Billabong Creek Regulators

Request for additional information

September 2025

Department or Agency reference number: DOC25/273533

Figure 2.1 Top and bottom of the 100mm depth of the regulator's normal operating range.

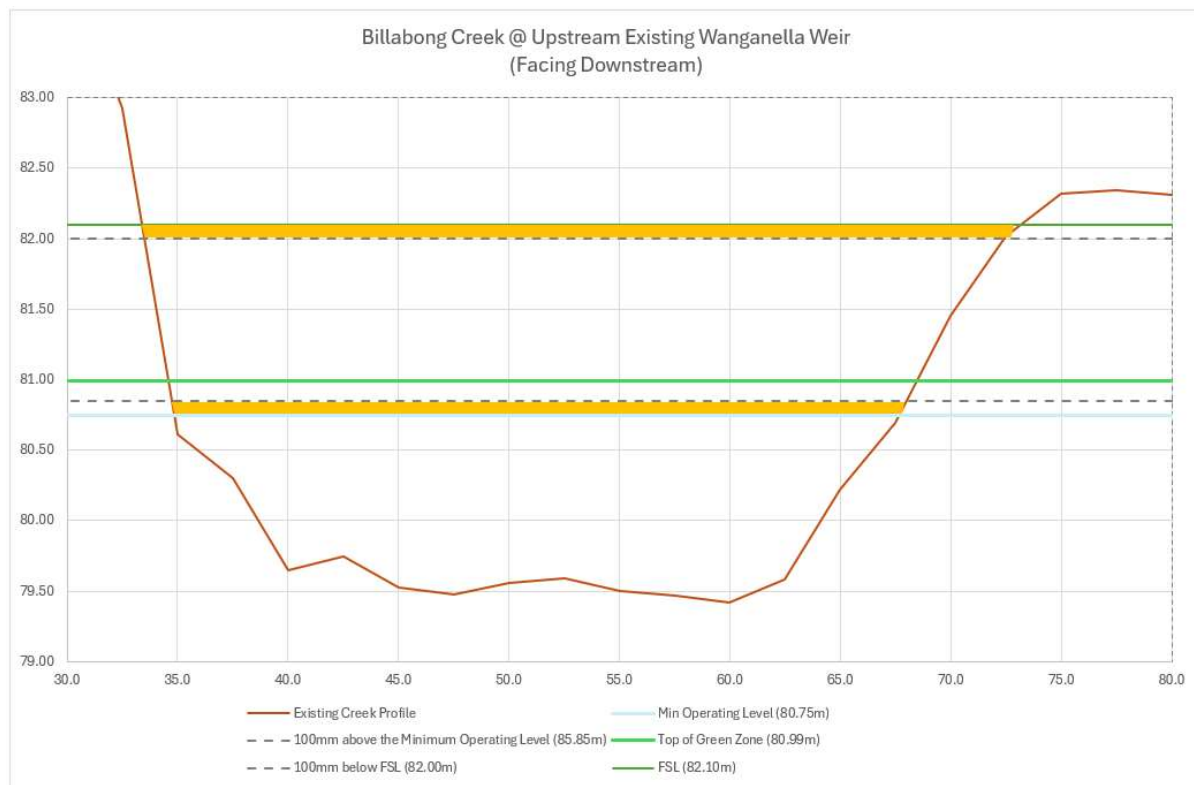
Confirm the rates of rise and fall for both regulators including the use of flow volumes as surrogate for rates of rise and fall. Further detail the environmental impacts of rise and fall.

NSW DCCEEW-Water Group does not support the surrogate use of flow volumes (i.e. daily changes in upstream weir pool storage volume) as an alternate for daily level rates of rise and fall within both the Hartwood and Wanganella weir pools. While the flow approach is used by WaterNSW at some other weir pools, and that for convenience WaterNSW would prefer to adopt similar arrangements at Hartwood and Wanganella regulators, NSW DCCEEW’s view is that it would not deliver the performance outcomes intended by the current Draft Yanco Creek System Operations Plan and would likely compromise the potential water delivery efficiency gains of the proposed new regulators.

The profile width of Billabong Creek progressively widens from the bottom to the top of banks at both Wanganella and Hartwood regulators. This results in more water being stored in a defined depth in the top of the weir pool compared to the same depth of water in the bottom of the weir pool.

In Figure 2.1, the two orange highlighted sections of the channel profile in the Billabong Creek upstream of the existing Wanganella Regulator represent the top and bottom 100 millimetres (mm) depth (Volume A and Volume B) of the regulator’s normal operating range.

Based on volumetric estimates determined from the Wanganella Regulator Storage Capacity Table, the top 100mm of the weir pool holds about 59 megalitres (ML) in storage volume (**Volume A**) compared to the bottom 100mm that only stores about 21ML (**Volume B**).

- If a storage volume rate of rise and fall was adopted, subject to the magnitude and methodology used, this would significantly increase the period of time that the weir pool is operated in the Yellow Zone (i.e. the higher levels) that the Draft Yanco Creek System Operations Plan strategically aims to minimise to reduce the potential risk of adverse outcomes to native fish and vegetation.

Figure 3.1 Hartwood – bushfire risk

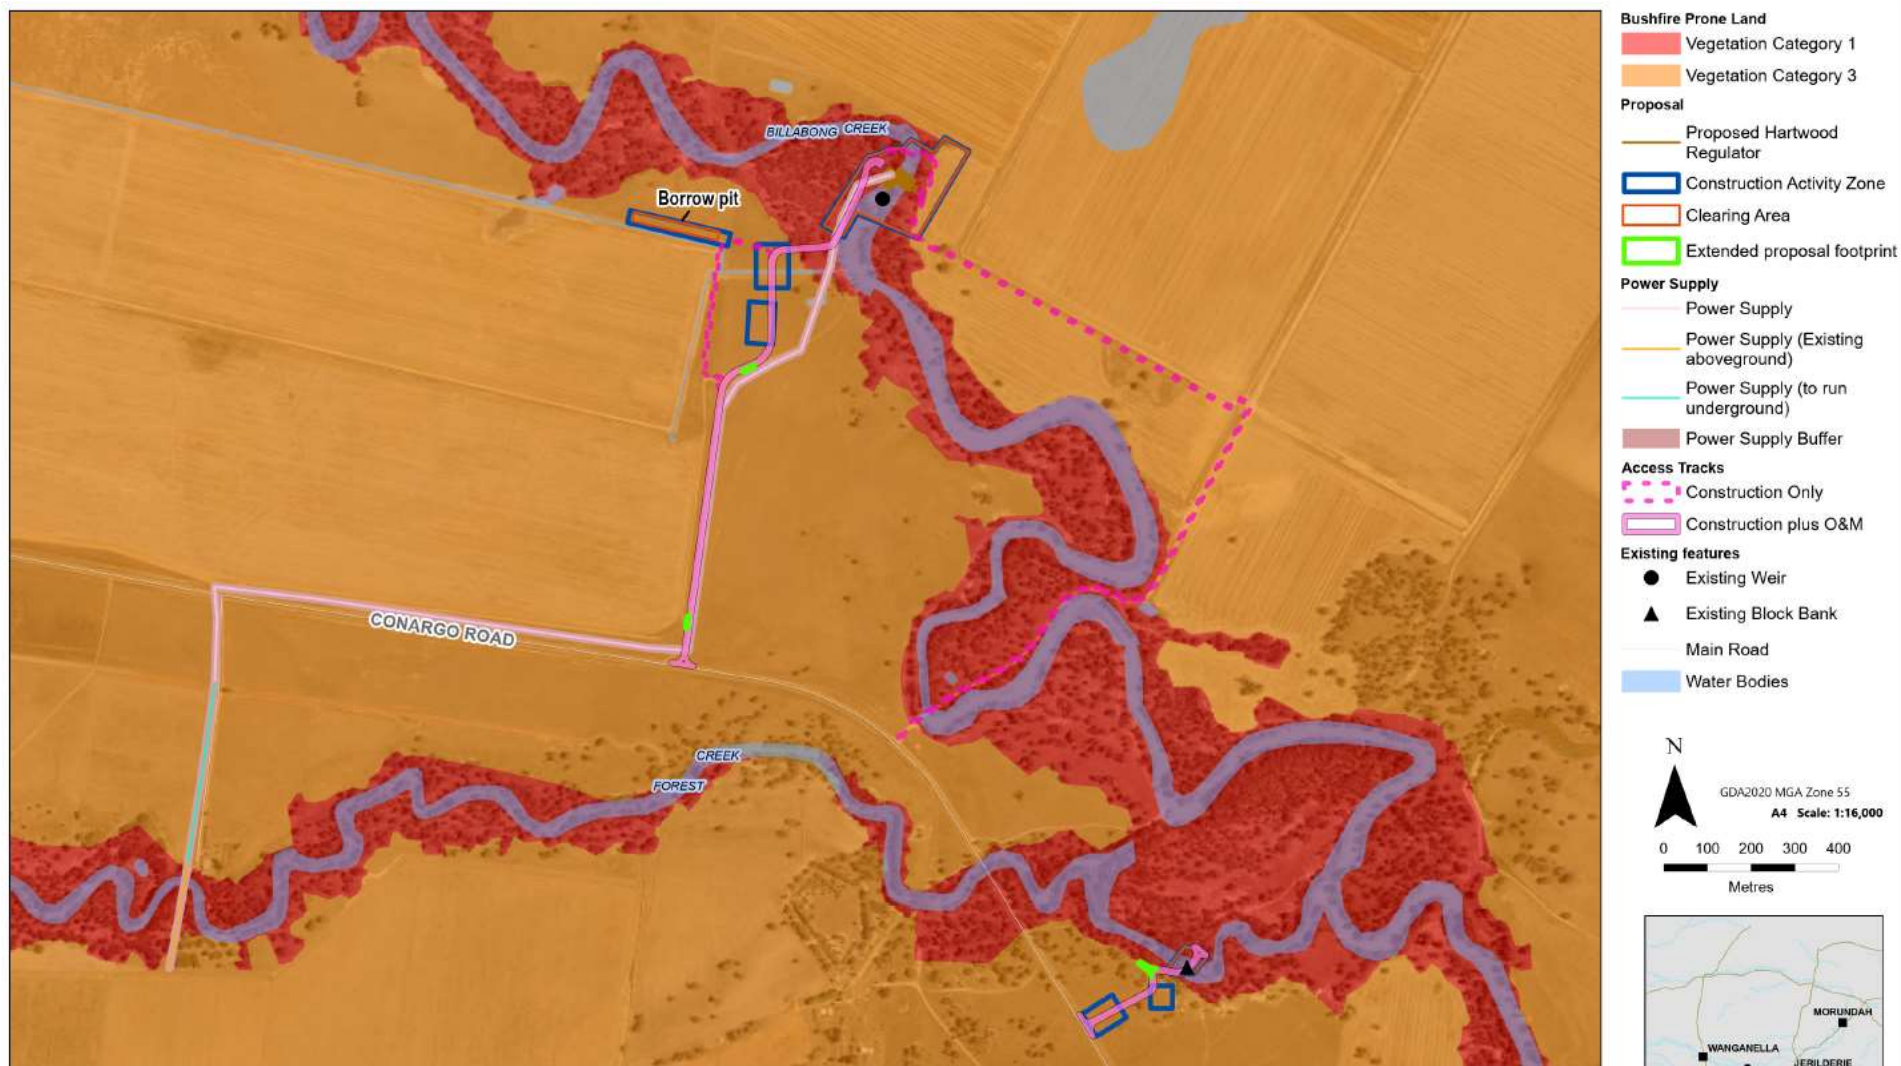
The Planning Portal Hazard – Bushfire Prone Vegetation Mapping Tool categorises the regulator sites and surrounding areas as Vegetation Category 1 (highest risk for bush fire) and Vegetation Category 3 (medium bushfire risk). Confirm vegetation categories around the regulator sites and provide detail on how bushfire risk will be considered during detailed design, in accordance with Planning for Bushfire Protection 2019 (NSW RFS) and Australian Standard AS 3959:2018 Construction of buildings in bushfire prone areas.

The Planning Portal Hazard – Bushfire Prone Vegetation Mapping Tool categorises bushfire prone land by the vegetation type within the area. A review of the location of the proposal sites and surrounding areas was conducted. The vegetation categories within and adjacent to the site include Vegetation Category 1 (highest risk for bush fire) and Vegetation Category 3 (medium bushfire risk). Figure 3.1 and Figure 3.2 show the location of the vegetation categories in relation to the proposal sites.
